Reasons for Denial of R3-2008-0020

Re: 74 Corona Road, Carmel Highlands (APN: 241-052-001); Waiver Resolution
R3-2008-0020
Our File: 32682.29781

RE: Resolution R3-2008-0020 (Draft) – Waiver of Waste Discharge Requirements

SUBJECT: Waiver of Waste Discharge Requirements for Engineered Onsite Disposal System, Kashfi Residence, 74 Corona Road, Carmel Highlands, Monterey County, Resolution No. R3-2008-0020

GROUND ZERO ANALYSIS	SITE ANALYSIS MAP 74 CORONA RD CARMEL HIGHLANDS, CA	FIGURE 2 FN 0308/730S
----------------------	---	-----------------------------

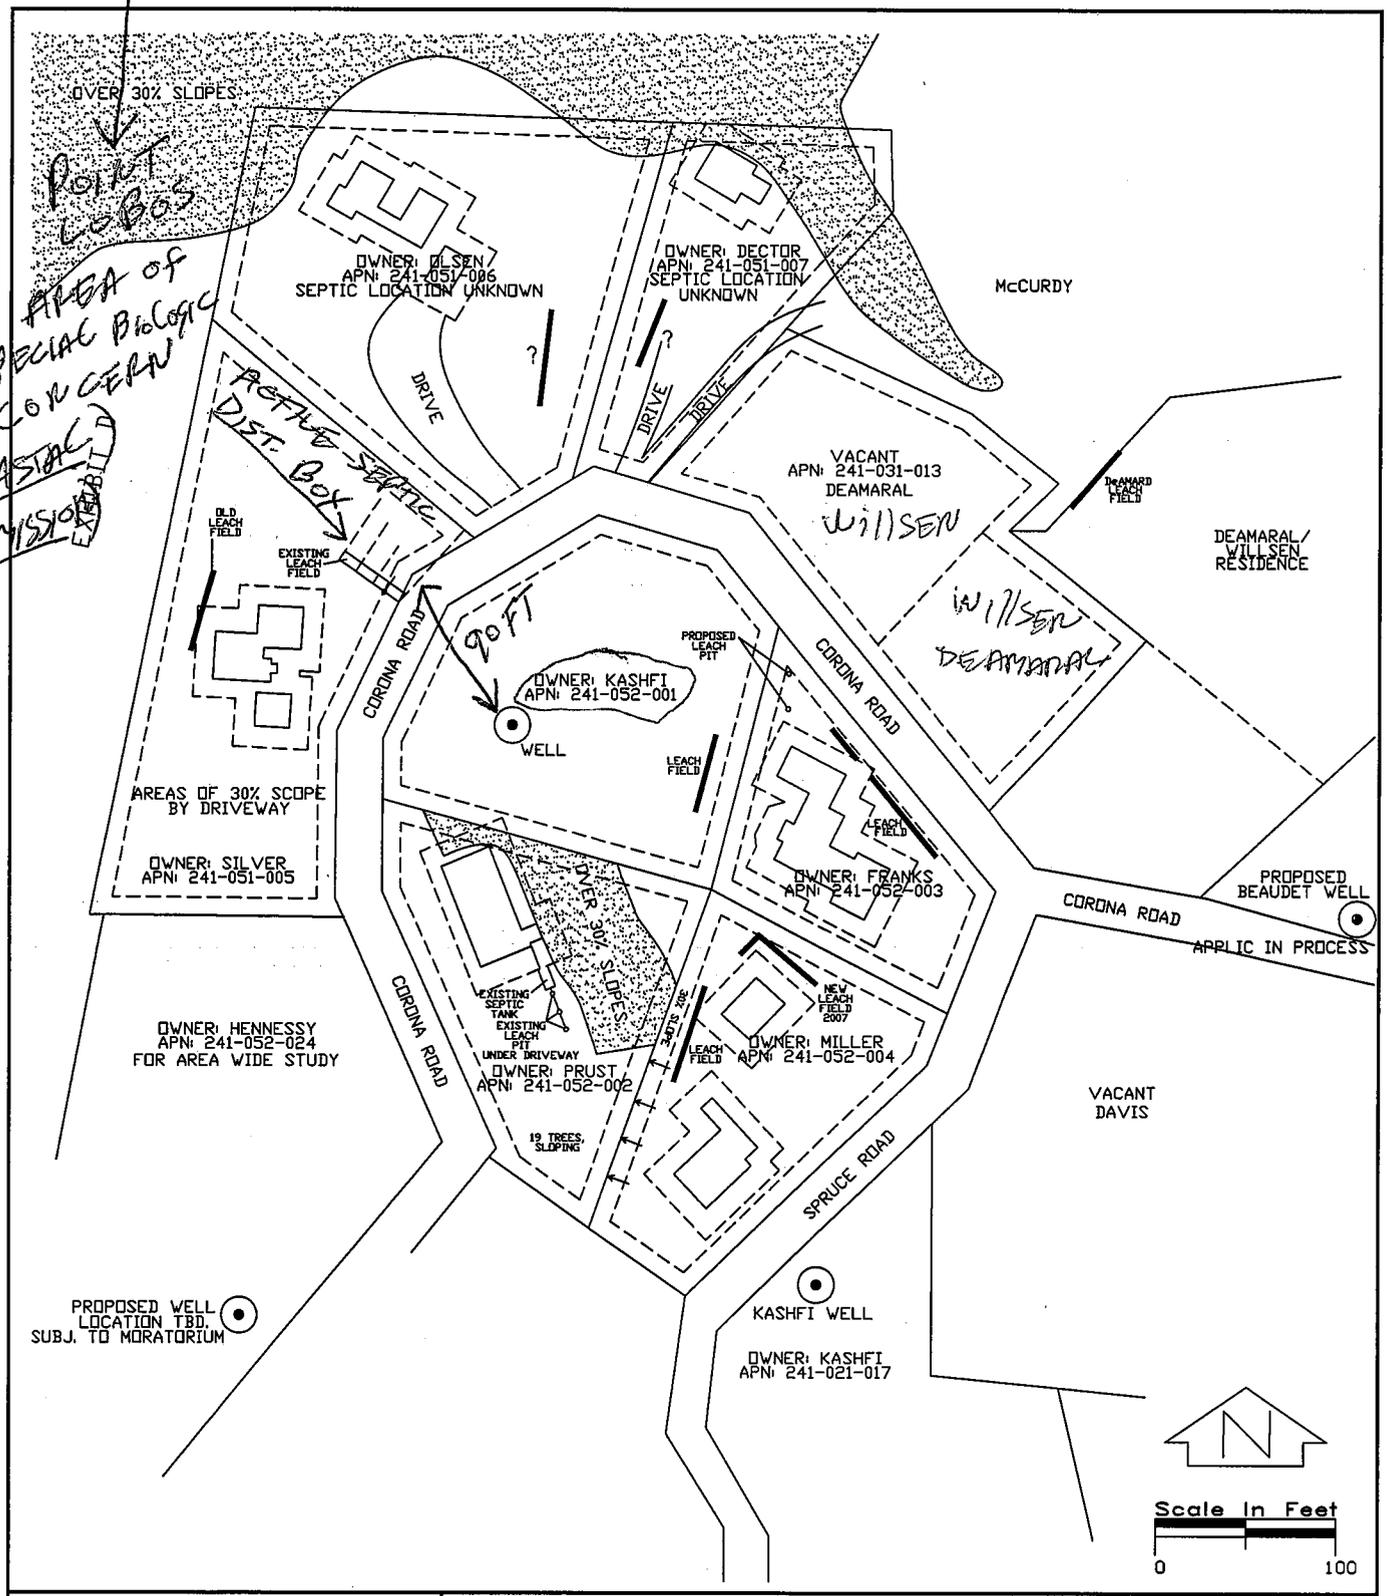
- The applicants well does not meet the setbacks based on a 90 foot distance from the neighbors D Box.
- The applicants well does not meet the Basin Plan condition of a 250 foot setback in fractured conditions.

- The well restricts neighbors ability to install replacement systems which are required by the County.
- The well will draw contaminants deeper into the fractured bedrock with potential hydraulic connections to Gibson Creek within the Point Lobos Reserve.

350 FT. FROM WELL

POINT LOBOS
AREA of SPECIAL Biologic CONCERN
COASTAL COMMISSION
